LIST OF MATERIAL				
PROPRIETARY RIGHTS NOTICE				UNLESS OTHERWISE SPECIFIED
THESE DATA ARE PROPRIETARY TO ERA AVIATION, INC. DISCLOSURE, REPRODUCTION, OR USE OF THESE DATA FOR ANY PURPOSE IS FORBIDDEN WITHOUT WRITTEN AUTHORIZATION FROM ERA AVIATION, INC. THE FOREGOING DOES NOT APPLY TO VENDOR PARTS.				X±.1 XX±.03 XXX±.010 ANGLES ±.1/2"
-001	2	41228-202-135		DRFTSMN T. HARVILLE 1/14/93
DASH NO.	REQ'D PER ASSY	NEXT ASSEMBLY	MDL	CHECK STRESS PROJ. ENGR.
				DWG. SIZE C SCALE FULL
			HEAT TREAT	
			FINISH	Era Aviation, Inc.
			REV.	41228-202-111 E

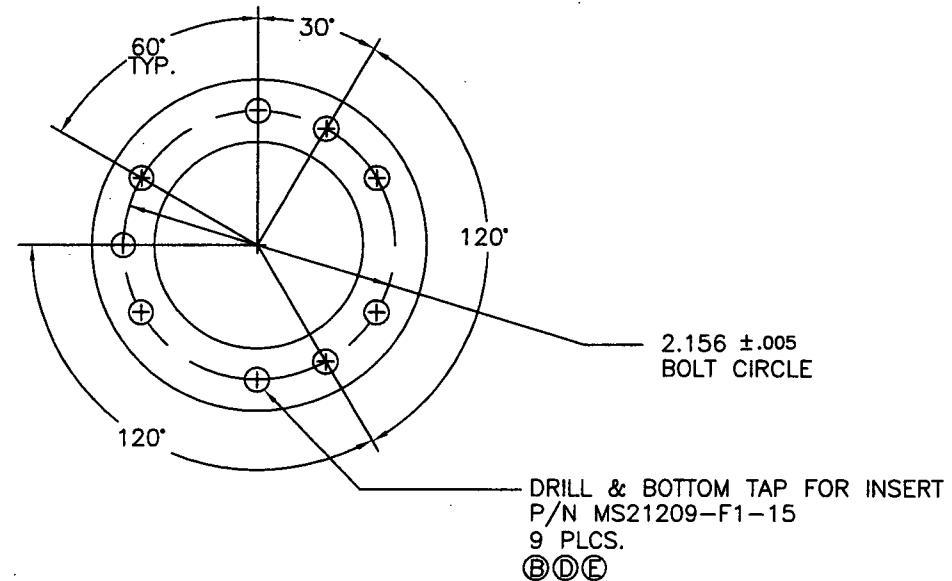
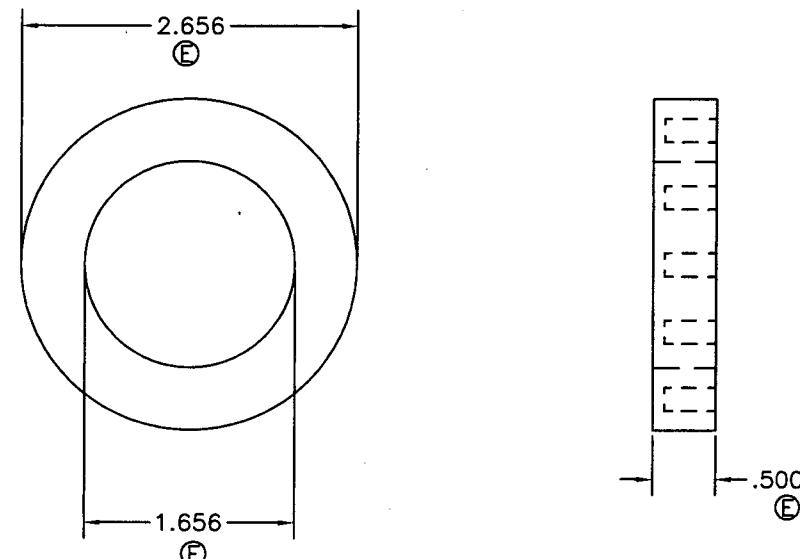
REVISION						
LETTER	DFTSMAN	DATE	DESCRIPTION		APPROVED	DATE
A	TAH	9/30/93	CANCELLED NOTE 1 & 2 ADDED NOTE 3. CHANGED MATERIAL. ADDED INSERT TO L/M & F/D			
B	TAH	10/8/93	REVISED NOTE 3. ADDED INSERT DEPTH TO F/D			
C	TAH	11/29/93	ADDED BOLT CIRCLE DIM TO NUT RING			
D	TAH	2/10/94	REMOVED INSERT P/N MS21209F1-20 FROM L/M & F/D ADDED 3 ea. MS21209 F4-20 INSERT TO L/M & F/D			
E	TAH	8/25/94	CHANGED 9 ea. INSERT P/N MS21209-F4-20 TO MS21209-F1-15. CHANGED DIM ON NUT RING.
